**SHINE MEDICAL TECHNOLOGIES, LLC OPERATING LICENSE APPLICATION
SUPPLEMENT NO. 2**

**FINAL SAFETY ANALYSIS REPORT CHANGE SUMMARY
PUBLIC VERSION**

FINAL SAFETY ANALYSIS REPORT MARKUP

Figure 7.4-1 – TRPS Logic Diagrams
(Sheet 12 of 13)

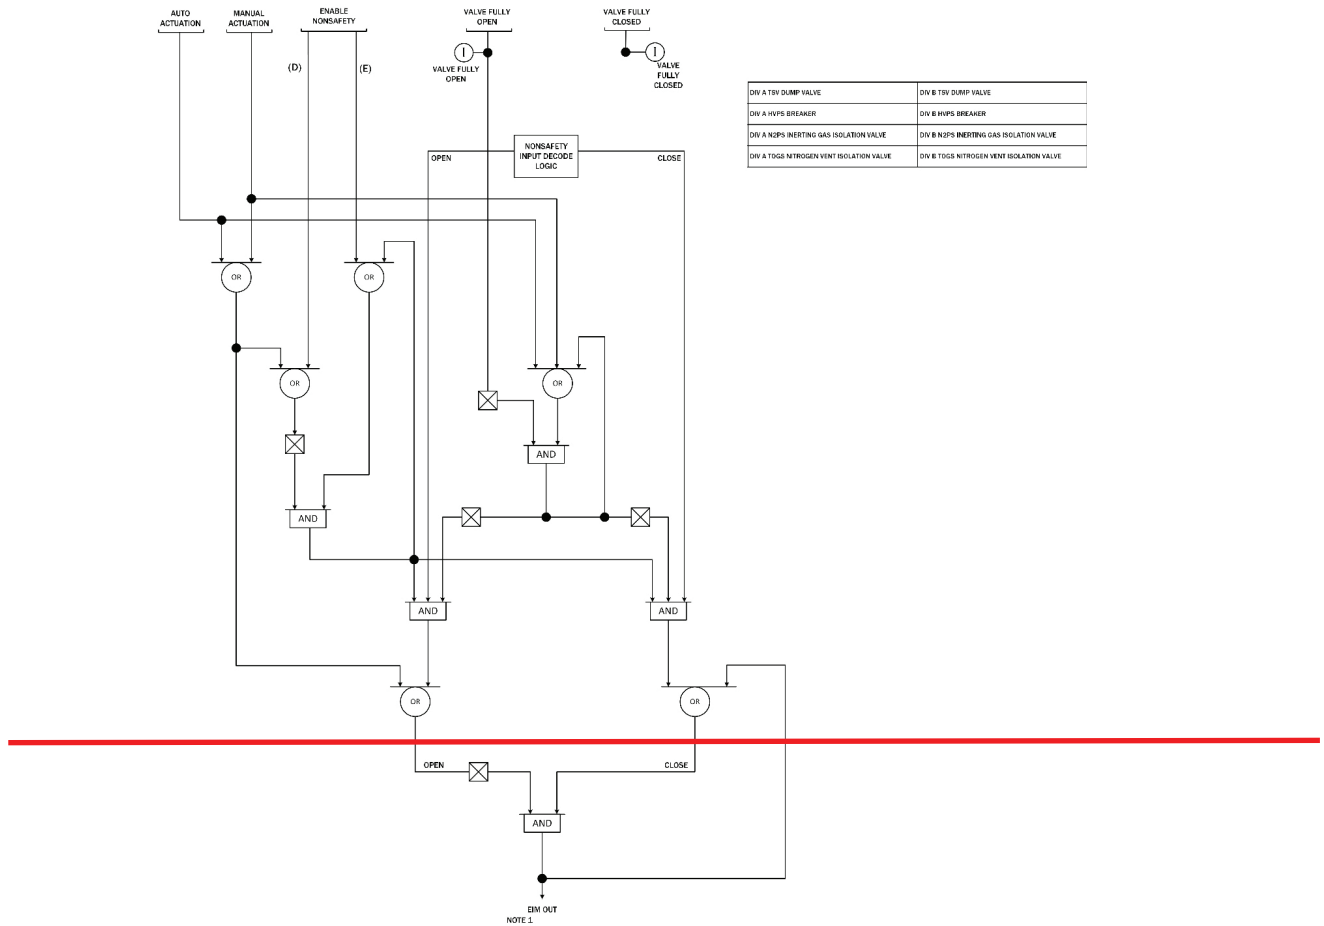
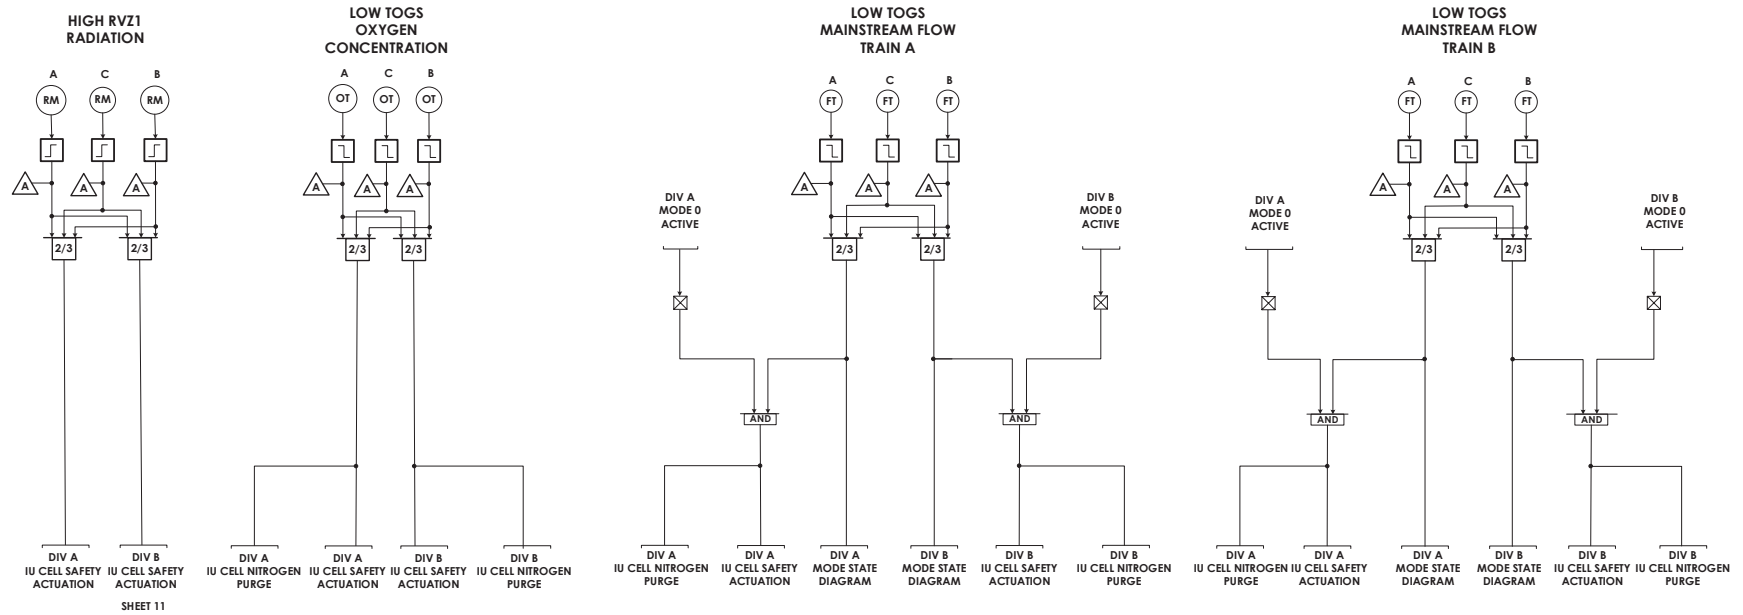
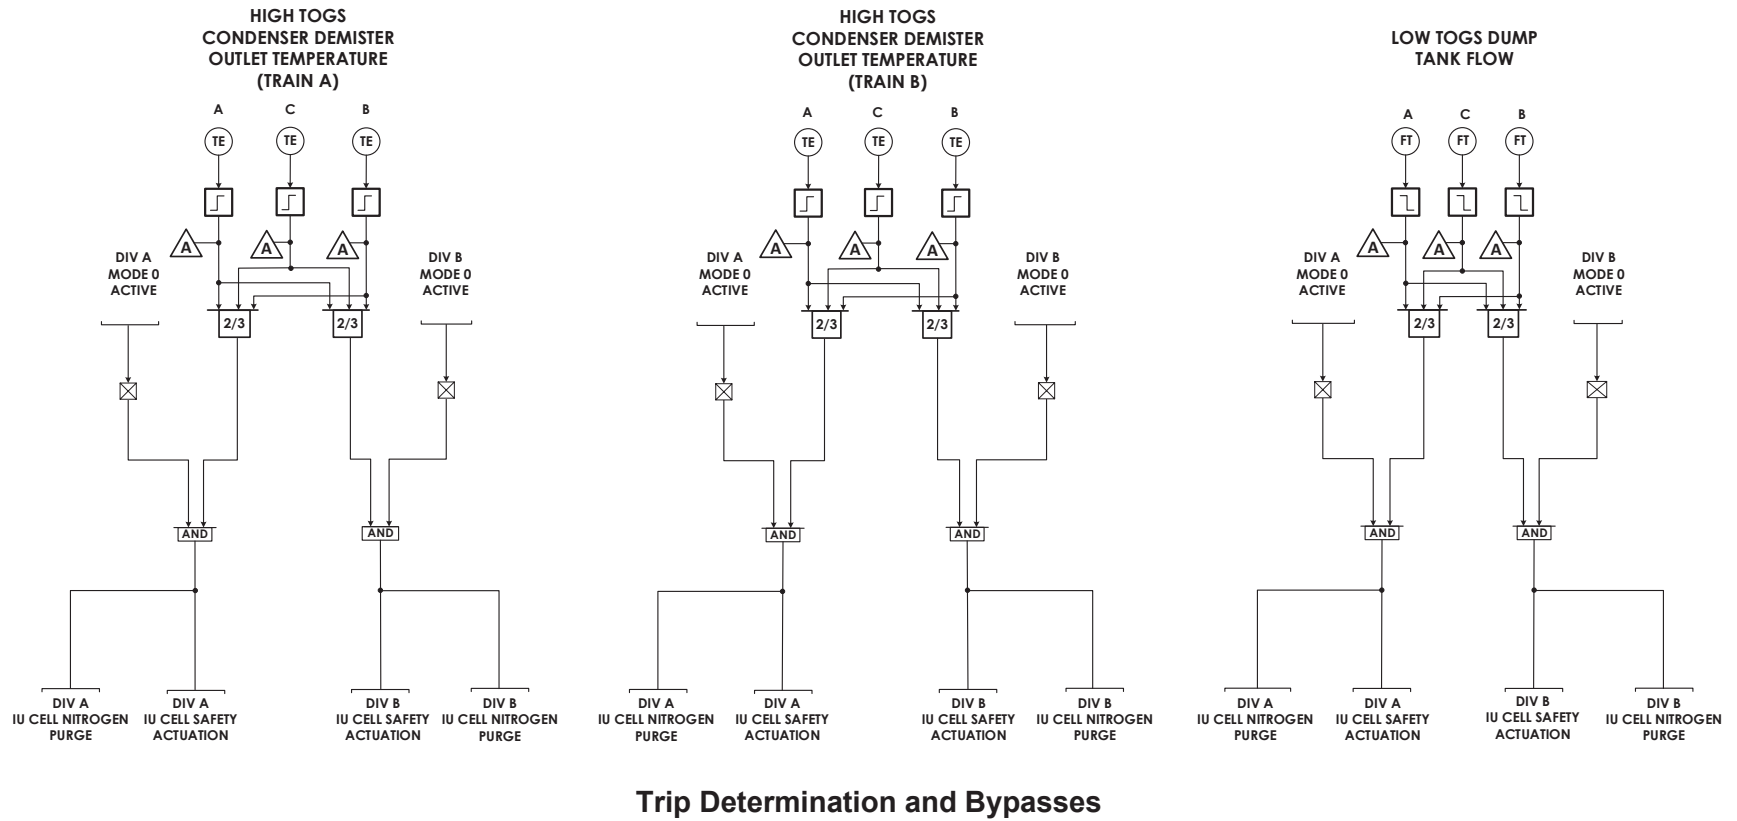
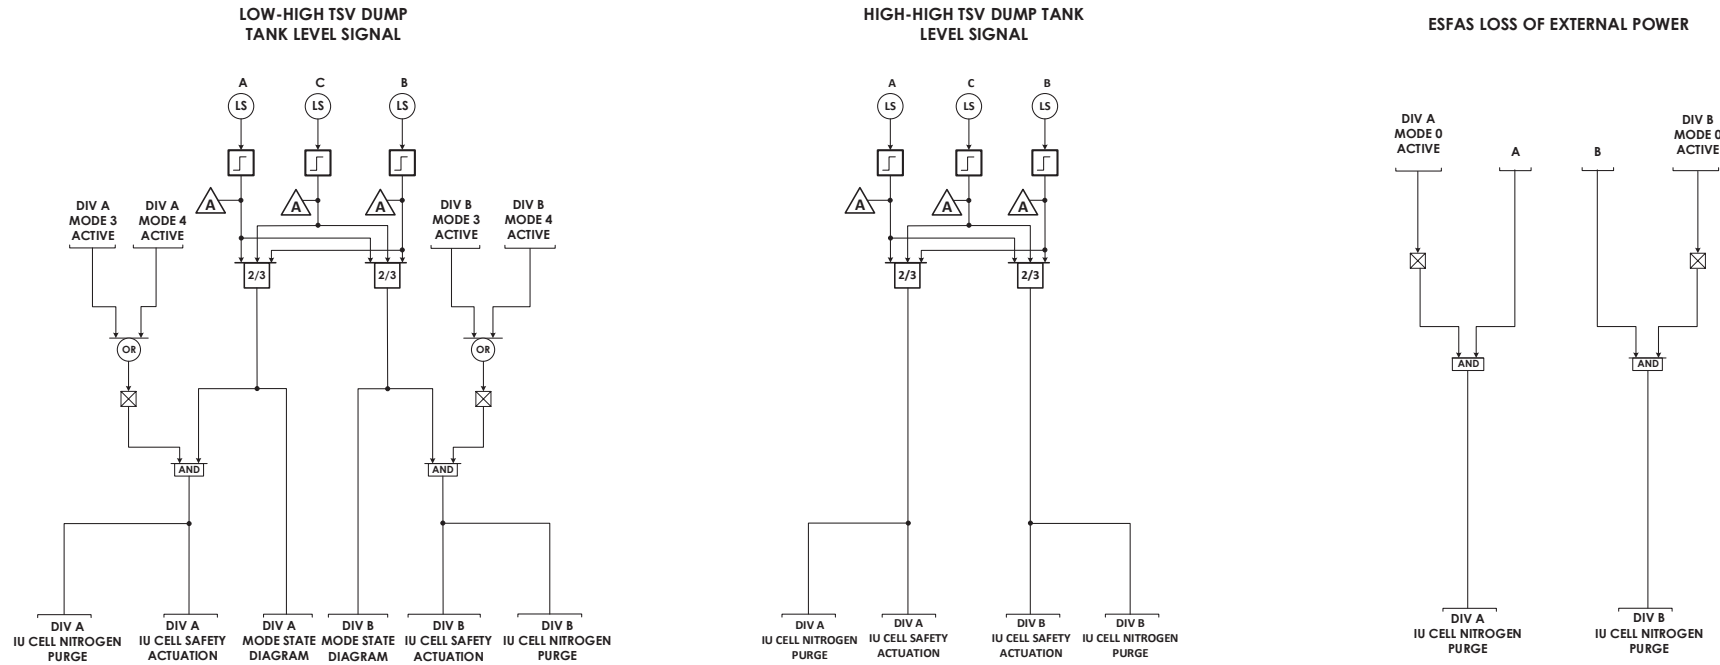
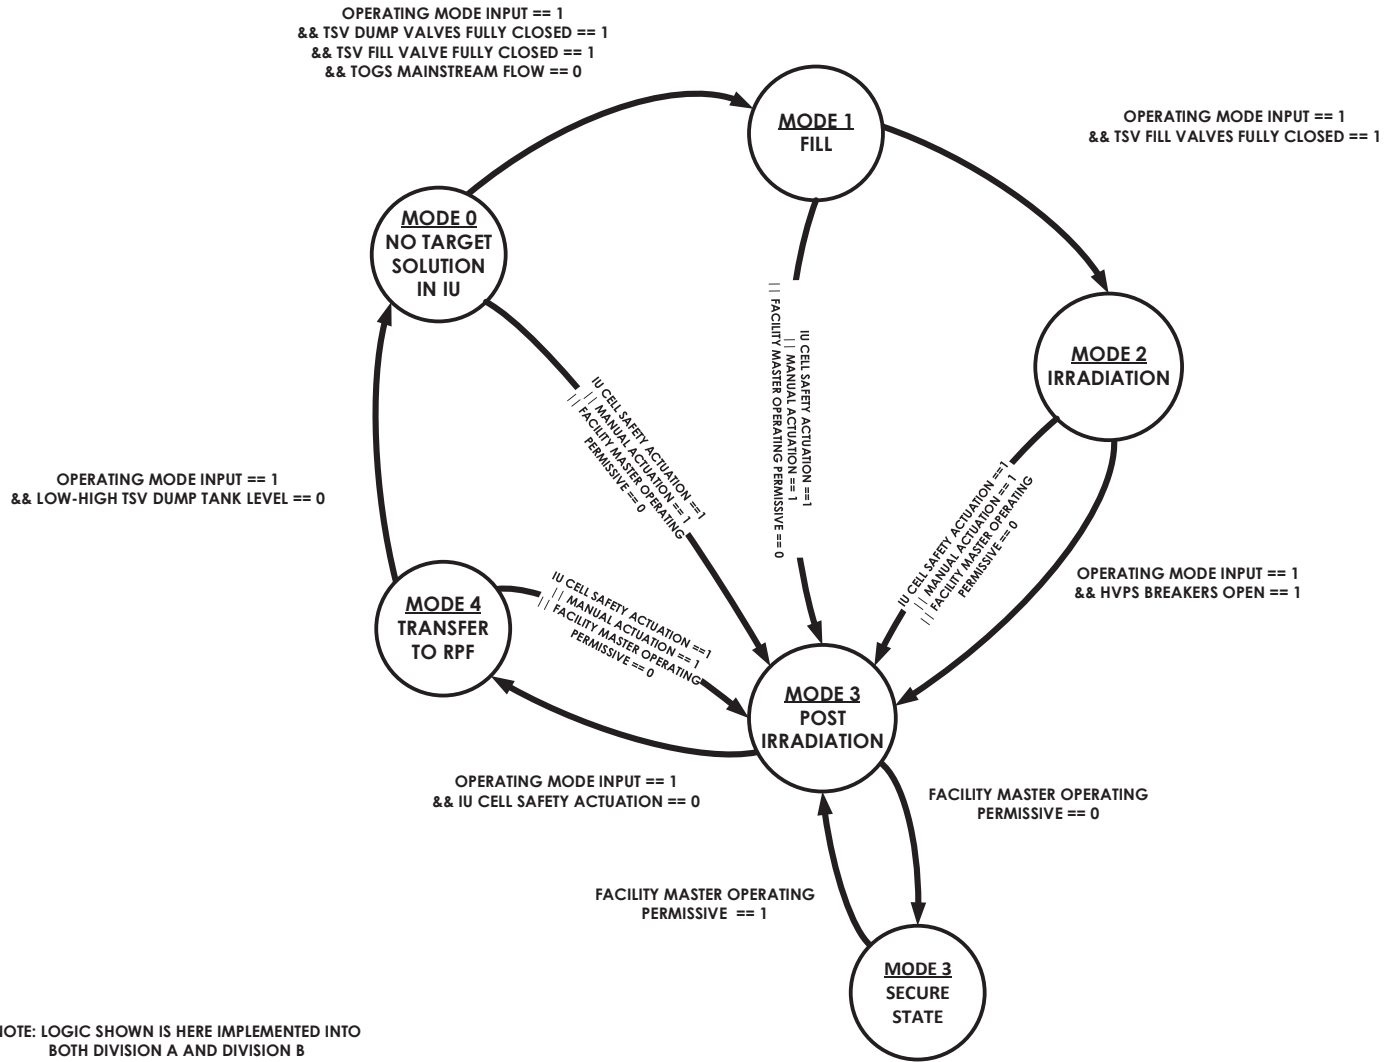
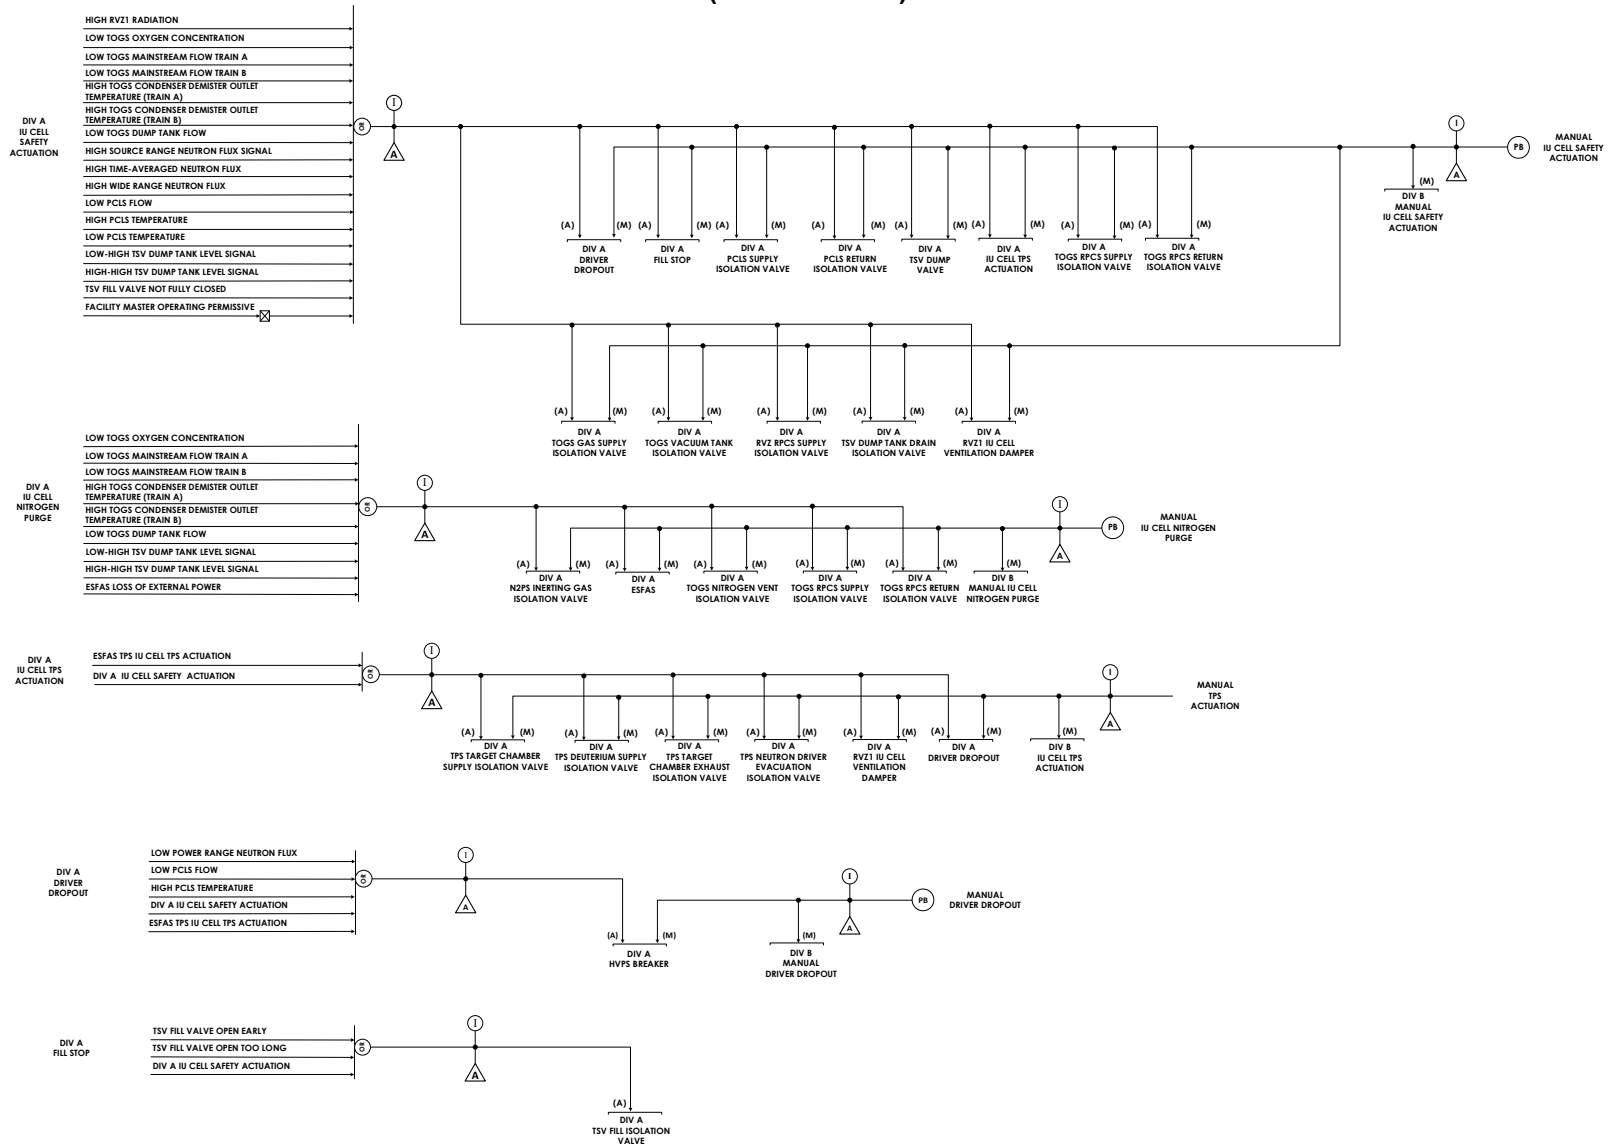
<p>Update to incorporate primary closed loop cooling system (PCLS) design changes. The PCLS design has been updated to incorporate SHINE design criteria 34, confinement isolation. This change improves the reliability of PCLS isolation safety functions.</p>	<p>Table 3.1-1, Section 5a2.2, Figure 5a2.2-1, Section 7.4, Figure 7.4-1</p>

~~Figure 7.4-1, Sheet 11 and Sheet 12,~~ shows how the TRPS latches in a protective action and maintains the state of a protective action until operator input is initiated to reset the output of the TRPS.
